# 1.0 INTRODUCTION

This document, along with the edited version<sup>1</sup> of 2011 2<sup>nd</sup> Revised Draft Environmental Impact Report (2011 2<sup>nd</sup> Revised Draft EIR or 2011 2<sup>nd</sup> RDEIR), represents the Final Environmental Impact Report (Final EIR) for the Consideration of Modifications to the U.S. Bureau of Reclamation's (Reclamation) Water Rights Permits 11308 and 11310 (Applications 11331 and 11332) to Protect Public Trust Values and downstream Water Rights on the Santa Ynez River below Bradbury Dam (Cachuma Reservoir) (hereafter referred to as the "proposed project"). It has been prepared in accordance with the California Environmental Quality Act (CEQA) (Public Resources Code Section 21000 et seq.), and its implementing guidelines (California Code Regulations, title 14, Section 15000 et seq., [*State CEQA Guidelines*]) as amended.

**Re: Palmer Gavit Jackson Trust Comments to Second Revised Draft EIR Prepared for and Relating to the Modifications of the U.S. Bureau of Reclamation's Water Right Permits 11308 and 11310 (Applications 11331 and 11332) regarding the Cachuma Project on the Santa Ynez River**

Figure 1. Combined frequency of scores 4 and 5 from RDEIR Tables 4-43-4-45.

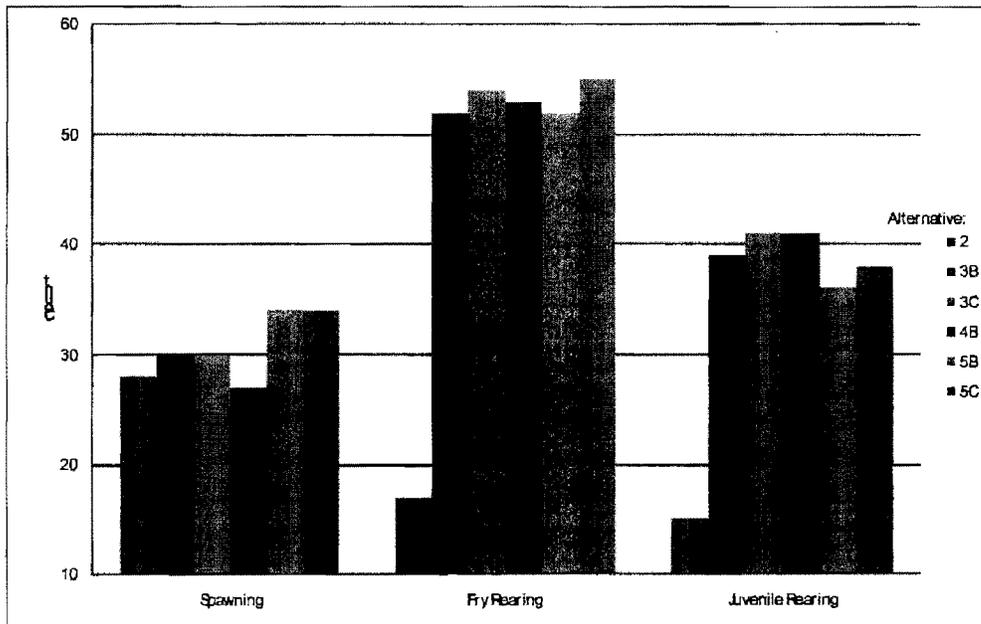
a slight advantage over Alternatives 3B, 3C, 4B and 5B for fry rearing (RDEIR Table 4-44; Figure 1 below), Alternatives 3B, 3C and 4B have an advantage over Alternatives 5B and 5C for juvenile rearing (RDEIR Table 4-45; Figure 1 below). Habitat bottlenecks during the juvenile lifestage affect later life stages, i.e., the adult steelhead population size. This would eliminate any minor advantage that could accrue for steelhead during the spawning or fry stage. Steelhead fry produced during the spring grow into juvenile fish and continue to reside in the River through the fall and into the winter when habitat is limited. Thus, any additional fry produced under Alternatives 5B or 5C must pass through a habitat bottleneck occurring during the juvenile rearing stage. Alternatives 3B and 3C and Alternatives 5B and 5C provide similar flows in fall and winter. Therefore, in view of the potential limitations to juvenile rearing in the lower Santa Ynez River, Alternative 5B or 5C would not be expected to increase production relative to Alternative 3B or 3C, since the same habitat limitation would apply at the juvenile rearing stage. These considerations indicate that it is unlikely that Alternatives 5B and 5C will provide any additional benefit to steelhead/rainbow trout over Alternatives 3B and 3C.

CCRB concurs with the statement that additional flow from Alternatives 5B and 5C would not necessarily provide favorable rearing conditions in the Alisal Reach. As discussed in the 2011 RDEIR, the limited habitat potential of this reach was also recognized in the Biological Opinion which placed this reach at the low level of priority.

**Figure 1**  
**Cachuma Project Incremental Shortages Compared to Alternative 1**  
**in Critical Drought Period, 1949 through 1951**

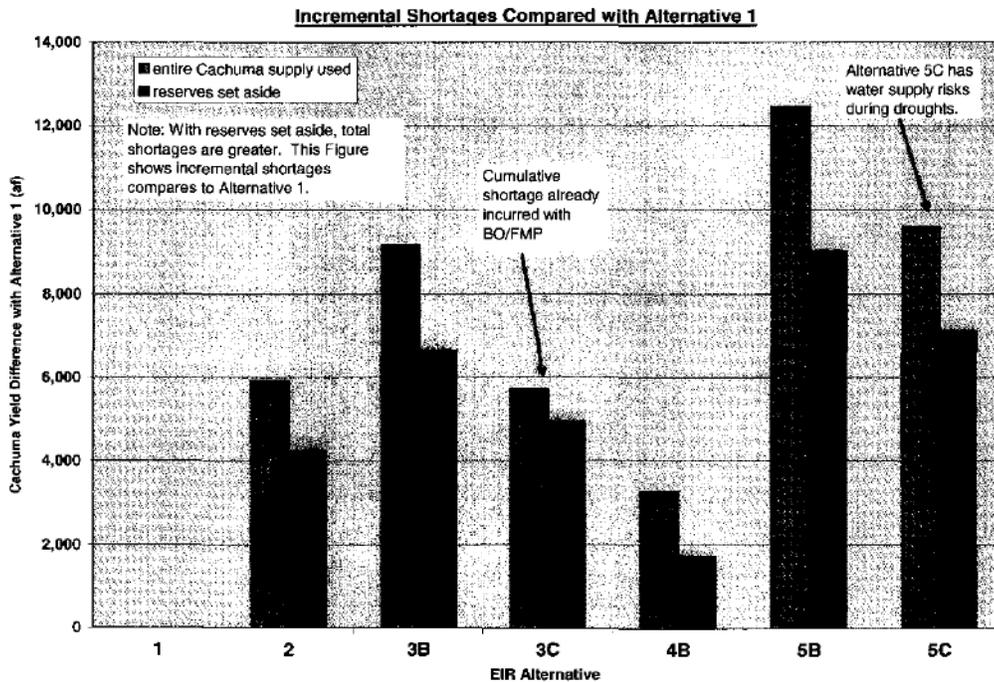
- Alternatives 5B and 5C pose an unknown risk to Cachuma Project water supplies by requiring much larger continuous flow targets at Alisal (Solvang) bridge during the summer months (10 to 25 cfs) than that which has been reviewed and planned for under the Fish Management Plan (1.5 cfs). The primary target site for current operations under the long-term BO/FMP is the Highway 154 bridge located about 3.5 miles downstream Cachuma Lake. Alisal bridge is located about 10.5 miles downstream and is subject to more variables that affect flows which are beyond the control of the Cachuma Project operations.

**Figure 2**  
**Frequency of Net Gain/Loss between Bradbury Dam and Solvang Bridge**  
**April through September, When 1.5 cfs Target Flow at Solvang Bridge is in Effect**

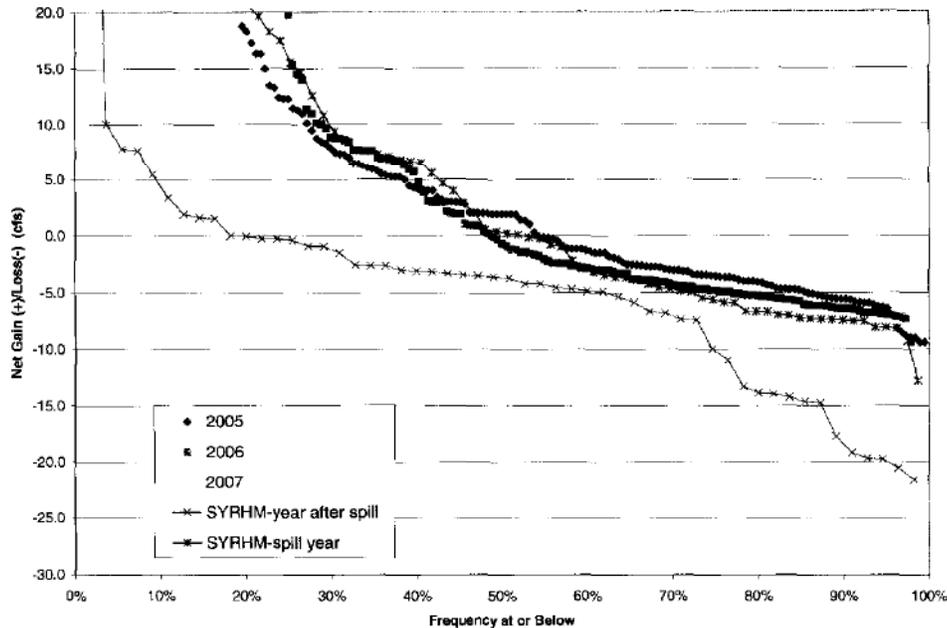
Recent operations for releases for fish indicate that 1.5 cfs at Alisal bridge in itself poses a risk to Cachuma Project water supplies in certain years such as 2007. Under the BO and FMP, long-term operations (Alternative 3C) in a spill year greater than 20,000 cfs and in the year after a spill, provide that the target flow at Alisal bridge is 1.5 cfs. In fact, BO/FMP long-term operations began after the spill in 2005. 2006 was also a spill year, and 2007 is the year after a spill. However, 2007 also happens to be the driest year on record at Cachuma Reservoir in the year after a spill. The SYRHM is based on years 1918-1993. The consequence is that much *more* water had to be released than expected under the SYRHM as shown in Figure 2. Sensitivity analyses regarding losses from Cachuma to Solvang bridge and the target flows at Solvang bridge are definitely needed, particularly for an analysis of the reservoir releases contemplated by Alternatives 5B and 5C, for which the SYRHM has not been calibrated.

**Figure 3**  
**Excerpt from USGS Water Supply Paper 1366**  
**Ground-water Level Decline near Carpinteria and Goleta (1940-1951)**

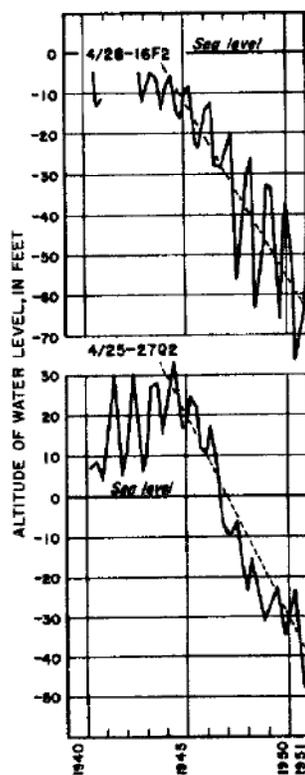
- Potential mitigation of the increase in Cachuma Project shortages caused by the DEIR’s alternatives through increased ground-water pumping also requires a more comprehensive review of impacts. For example, in “Water Resources of Southern California with Special Reference to the Drought of 1944-51” (USGS, 1957), the ground-water tables near the Member Units showed considerable decline as illustrated below in Figure 3. The indirect environmental impacts from ground-water pumping during droughts, such as possible sea water intrusion, requires more discussion than is provided in the 2007 DEIR. Currently, the document provides no information or evaluation of local groundwater rights, overall short- and long-term supplies compared to local demand, or the likelihood of those additional supplies proving available in light of legal, technical or other limitations. (2007 DEIR, p. 4-30.) Instead, the analysis simply assumes that significant amounts of groundwater will be reliably and legally available to the Member Units, contrary to the requirements of *Vineyard Area Citizens for Responsible Growth v. City of Rancho Cordova, supra*, 40 Cal.4<sup>th</sup> 412. (See, e.g., 2007 DEIR, Table 4-25b; Appendix F, Tables 19A-B.) This inadequate analysis results in a gross understatement of water supply impacts to the Member Units.

**Figure 1**  
**Comparison of minimum monthly flows for Alternative 3B and 3C and 5B and 5C during the fry rearing period when Alternative 5B and 5C receive a score of 5<sup>3</sup>**

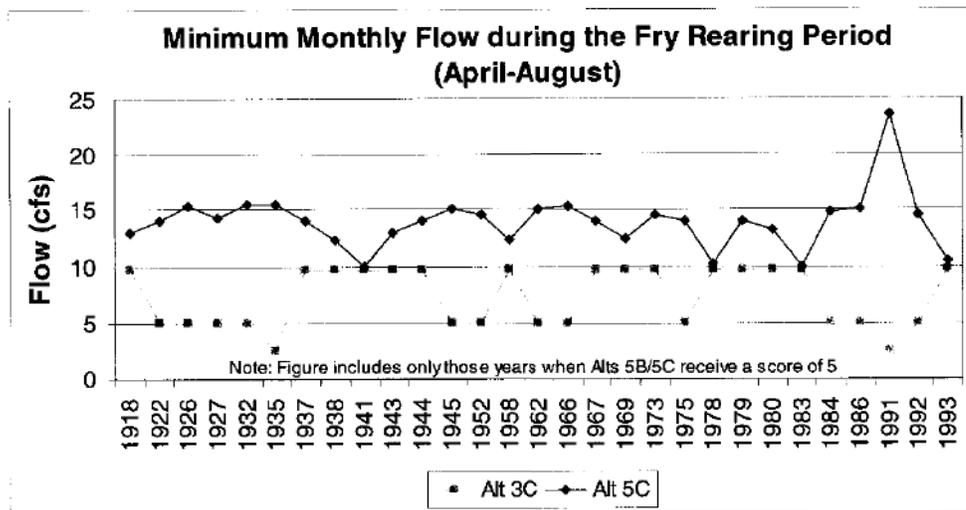
First, the DEIR should note that, while Alternatives 5B and 5C result in an increased frequency of years receiving a score of 5 for fry rearing, all of the alternatives have almost the same number of years receiving scores of 4 or 5, indicating that habitat values are high. During the fry rearing period in years when fry habitat receives a score of 5 under Alternatives 5B or 5C, these alternatives provide an average of 6 cfs more flow than Alternatives 3B and 3C. (See Figure 1 below.) This difference in flow is very significant to the Member Units, but results in only a minor change in habitat for the steelhead. Based on the top-width vs. flow information presented in the Habitat Analysis (SYRTAC 1999a), the difference in top width at flows of 5 and 15 cfs (the range of increase in flows under Alternatives 5B/5C as compared to Alternatives 3B/3C) would range from 4 to 9 feet. (See Figure 2 and Table 1 below.) These changes correspond to an increase in top width of only 6 to 9 percent depending on habitat type. Thus, the increased amount of habitat provided under Alternatives 5B and 5C relative to that under Alternatives 3B and 3C would be small. This small increase in habitat, in spite of relatively large increases in flow occurs because the 10 to 20 cfs summer flows required by Alternatives 5B and 5C, falls far above the breakpoint of the top width vs. flow function. As shown in Table 1 and Figure 2 (replicated from SYRTAC 2000b), top width increases most rapidly as flows increase from 0 to 5 cfs. As flows increase above 5 cfs, the rate at which top width increases drops substantially. Thus, increasing habitat substantially above this breakpoint comes at a much higher water cost.

**Figure 2**  
**Top Width vs. Flow in the Highway 154 reach. (Note: y-axis is measured in feet)**

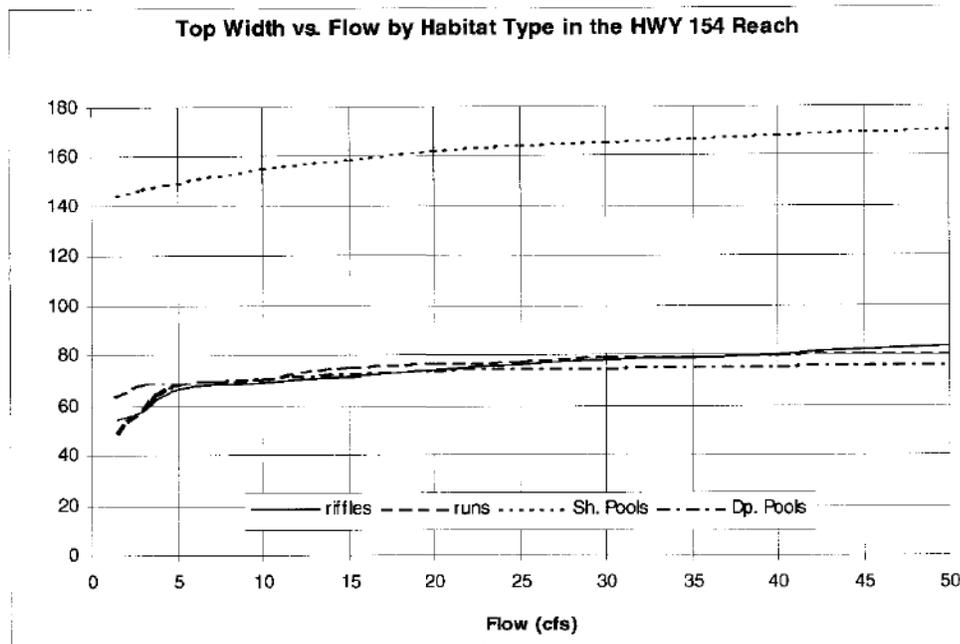
Second, monitoring data show that the additional 10 to 15 cfs minimum summer rearing flows provided under Alternatives 5B and 5C will not improve *other* aspects of habitat that may limit the production of steelhead/rainbow trout even if the volume of fry rearing habitat is increased. For example, data collected by the SYRTAC and presented at the State Board Phase II hearings show that even flows of 50 cfs do not reduce water temperatures in the Highway 154 reach. (See discussion and Figure 3 below.) Thus, Alternatives 5B and 5C do not provide any temperature benefit to steelhead/rainbow trout.

**Figure 3**  
**Temperature vs. Flow just downstream of the Highway 154 Reach**  
 (Note: "Average" represents Average Water Temperature (degrees Celsius))

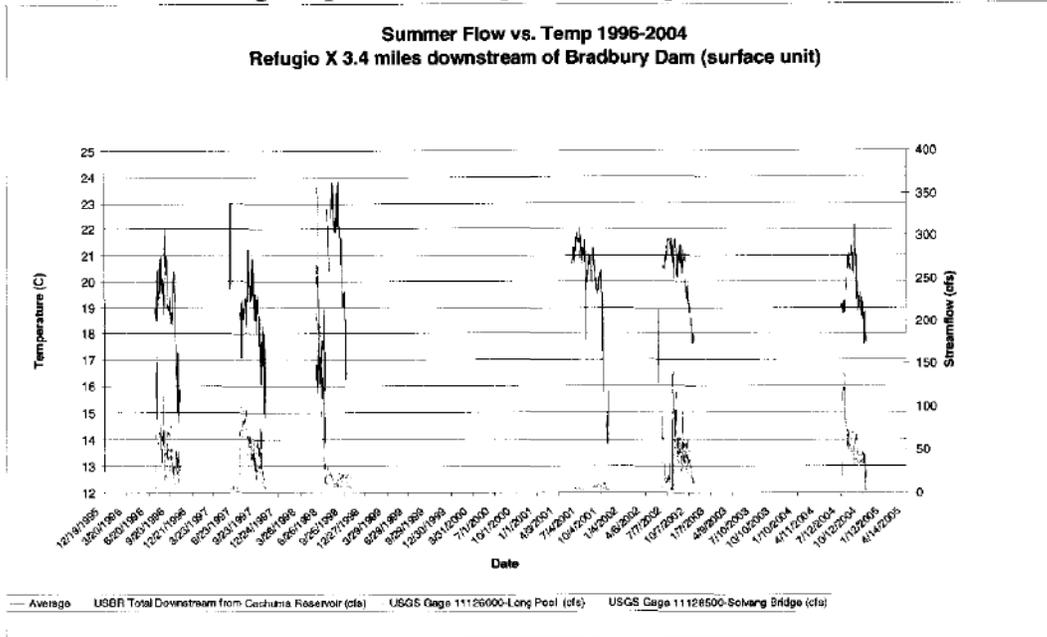
- Page 4-70. Alternatives 5B and 5C require flow releases that fail to take into account antecedent flow conditions and reservoir storage. As a result, Alternatives 5B or 5C may deplete reservoir storage without producing any noticeable fishery benefit. Alternatives 5B and 5C require flows to be maintained at both San Lucas and Alisal bridges during wet and

**Figure 1. Cachuma Lake Inflows for Years Following Spills of Greater than 20,000 AF Under Alternative 3C (1918-1993) Compared with Year 2007**

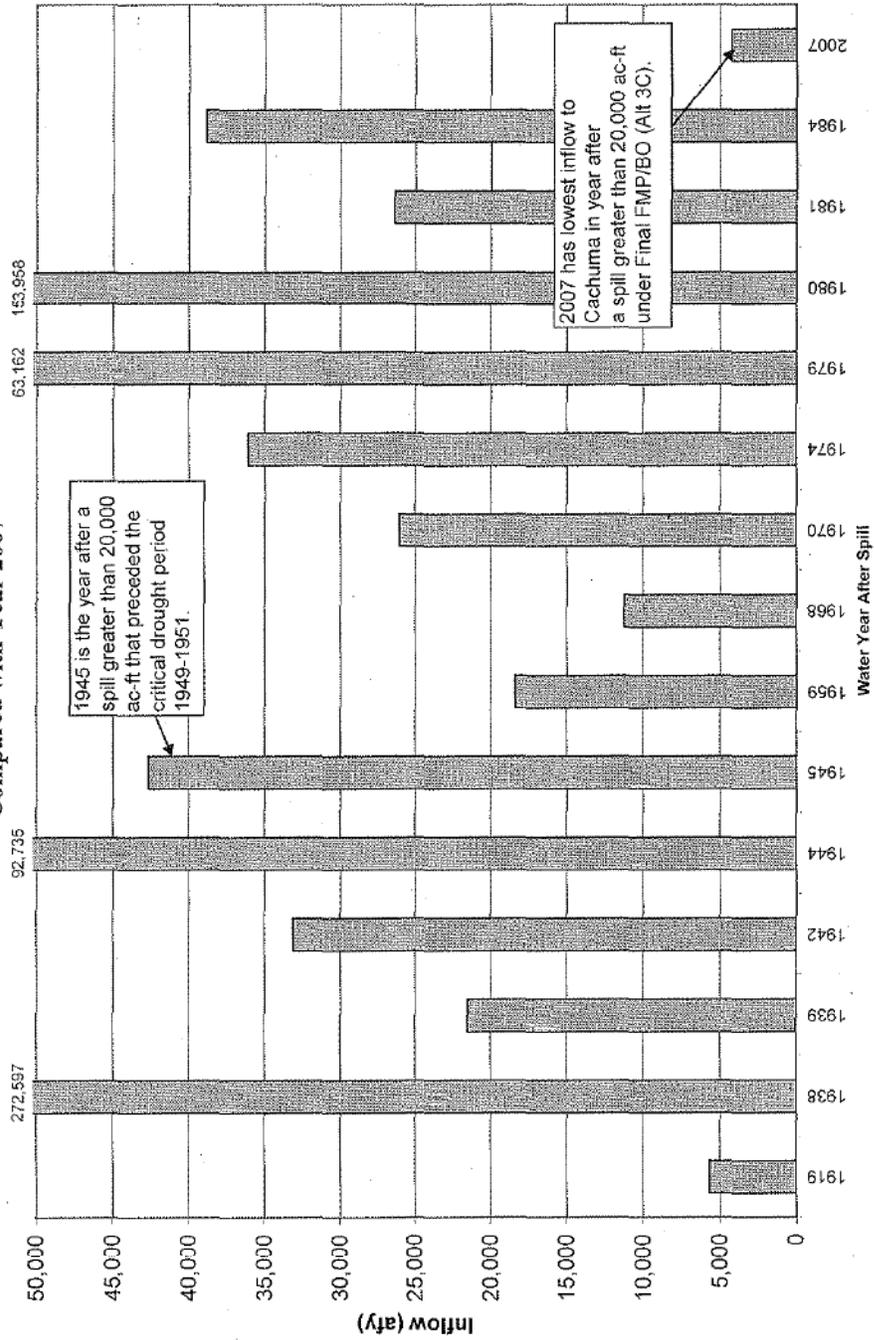
A year like 2007 was not predicted in the model analysis, which poses a risk to actual future water supplies from the Cachuma Project under the Final BO/FMP operations (Alternative 3C). The year 2007 is the driest year on record following a spill greater than 20,000 acre-feet as shown in Figure 1. Figure 1 compares the year 2007 runoff to the annual runoff in years following spills greater than 20,000 acre-feet within the base period (1918-1993) used in the SYRHM for the analysis of Alternative 3C. As of August 31, 2007, the cumulative annual runoff into Cachuma Reservoir starting from October 1, 2006 was only 4,262 acre-feet.

Figure 1: Graphical depiction of the RDEIR ranking for steelhead migration. Note that the ranking does not distinguish years with 14 days  $\geq$  25 cfs from days with 100 or more such days.

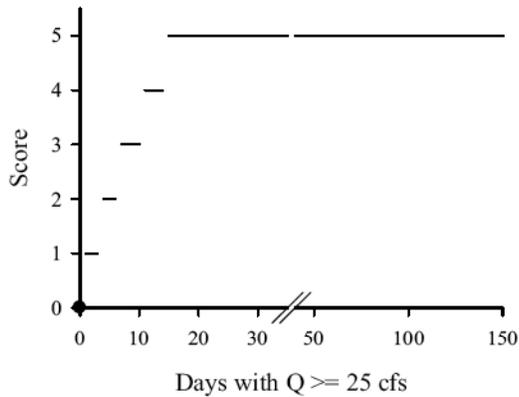
Besides being subjective, the RDEIR scoring system is biologically unsound. The scoring system is perhaps most deficient for steelhead migration (Figure 1), since it is based on a misreading of NMFS (2000) (hereafter also called the Biological Opinion) regarding the subject. At pp. 4-64 and 4-65, the RDEIR states that:

Figure 2. A figure from Swift (1976), showing the relation between average wetted perimeter and discharge, and identification of  $Q_r$ . Copied from Swift (1976).

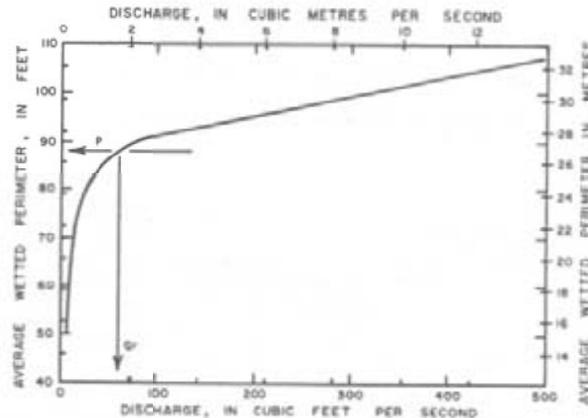
In other words, Swift (1976) developed empirical relations from a set of streams in western Washington for application to other streams in the region. Swift (1976) used plots of average wetted perimeter over discharge to identify what he called "rearing discharge",  $Q_r$ , as shown one of his figures (copied below as Figure 2), but he did not describe  $Q_r$  as the discharge producing optimal habitat or as the appropriate discharge for a flow standard. Rather, he described it as the discharge that "just covers the streambed," and stated that flow standards should be higher than  $Q_r$  (pp. 9-10):

Although it is not discussed in the works cited above, it seems an implicit assumption of the wetted perimeter method that the river does not run out of water, that is, that the discharge in the stream is more or less constant through the study reach, so that that the width measured at transects more or less reflects the area of the stream. The Santa Ynez River in the summer is a losing stream that does run out of water, at least on the surface, so a more complex analysis is required to take account of the relation between flow released from the dam and the resulting area of habitat. The RDEIR does not provide such an analysis.

Figure 4: Top width v. flow in the Hwy 154 reach, copied from SYRTAC (1999).

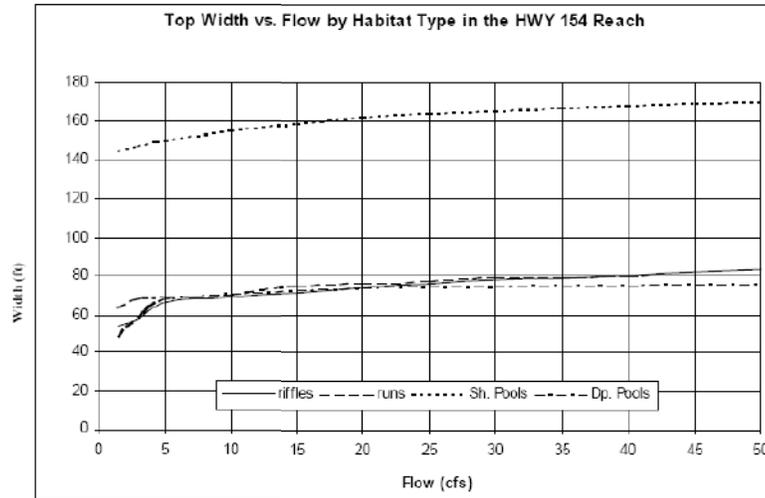
Finally, the RDEIR does not describe the results of SYRTAC (1999) accurately. As noted above, the RDEIR states that "In addition, the top-width versus flow relationships developed during the habitat analysis show that the rate of increase of habitat (i.e., top-width) typically declines above 10 cfs (SYRTAC 1999)." Actually, to the extent that there is a "breakpoint" in the curves, it occurs around 5 cfs, rather than 10 cfs, as shown for the Highway 154 reach in Figure 4. Thus, the faulty top-width analysis contradicts, rather than supports, the 10 cfs flow target given in the Biological Opinion.

Figure 4. A generalized relationship between flow and habitat for a given species and life-stage, in a given channel, copied from Gillilian and Brown (1997). This figure is from a discussion of PHABSIM, but the idea depicted of a domed shaped relationship between flow and habitat is more general.

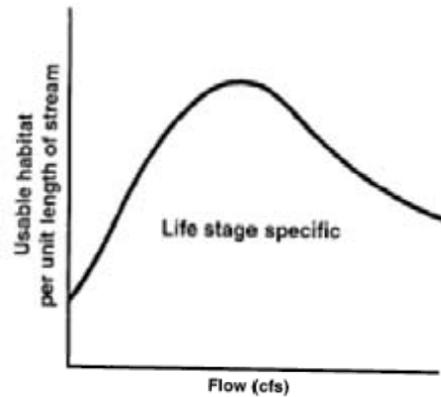
Moreover, on general grounds it seems highly likely that increases in flow beyond 10 cfs will increase the quality or quantity of habitat for juvenile steelhead. The usual assumption is that for a given species and life stage in a given channel there is some dome shaped relationship between flow and habitat, such as in Figure 3.1 in Gillilan and Brown (1997), copied here as Figure 4.<sup>7</sup> In general, the bigger the channel, the larger will be the flow at which habitat peaks. Thus, within the range considered by the RDEIR, the alternatives that provide higher flows, 5B and 5C (or 3A2 as modified by CalTrout), should provide better habitat conditions for steelhead.

Figure 5. Peak flows in the Santa Ynez River near Solvang; data from USGS gage 11128500.

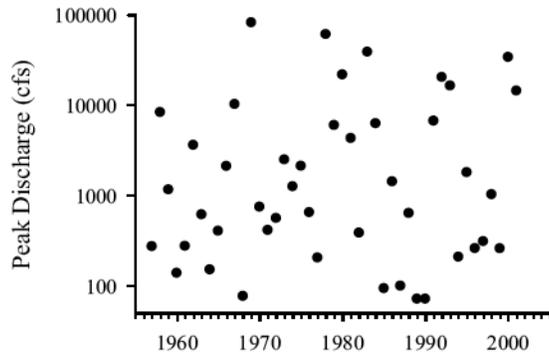
Peak flows greater than 10,000 cfs are common on the Santa Ynez River (Figure 5), and the channel can be expected to adjust to these flows, since the banks are generally non-cohesive. For a channel shaped by such large flows, it would be surprising if habitat did not continue to increase with flow well beyond 10 cfs.<sup>8</sup> Moreover, increased flows below Bradbury Dam should increase the longitudinal extent of suitable habitat, defined in terms of water quality, especially temperature, as well as the geometry of the channel. The potential effect of increased flows on the area of habitat can be seen in data from August 2005 (Figure 6). When releases from Bradbury Dam were increased from ~10 to ~13.7 cfs, flows farther downstream similarly increased, although with some time-delay. Note that the increase in releases resulted in more than a fourfold increase in discharge at Meadowlark, 5.4 miles below the dam. The RDEIR is deficient in not considering the longitudinal increase in potential habitat with increasing releases. Among other problems, this obscures the contrast between alternatives 5B and 5C and other alternatives that occur in simulated wet years.

Figure 7. The relationship between dissolved oxygen concentration and the length of hatching steelhead, based on Silver et al. (1963). [Copied from Williams 2006]

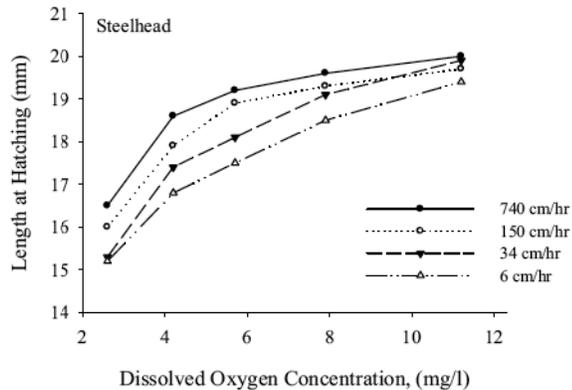
The RDEIR provides very little information on dissolved oxygen generally. However, according to the Biological Opinion (NMFS 2000; 48). “In the spring, fall, and winter, cooler temperatures and increases in flows appear to raise dissolved oxygen levels to 7-8 ppm in most cases.” The Biological Opinion further states that salmonids function normally at dissolved oxygen levels of 6-8 ppm. However, this is incorrect regarding embryos. The size of hatching steelhead is somewhat reduced at 7-8 mg/l,<sup>9</sup> compared to higher levels of dissolved oxygen (Figure 7), and dissolved oxygen in the redds will be lower than in the surface stream, likely by several mg/l, since dissolved oxygen is taken up by biological activity as it passes through the hyporheic (subsurface) zone (Hendricks and White 2000). Given the relatively low dissolved oxygen levels reported for the surface stream, dissolved oxygen in the hyporheic zone should be considered when assessing potential spawning habitat in the mainstem. Alternatives with higher flows during the incubation season for steelhead (i.e., 5B and 5C) should result in higher rates of hyporheic flow and better water quality in the hyporheic environment.
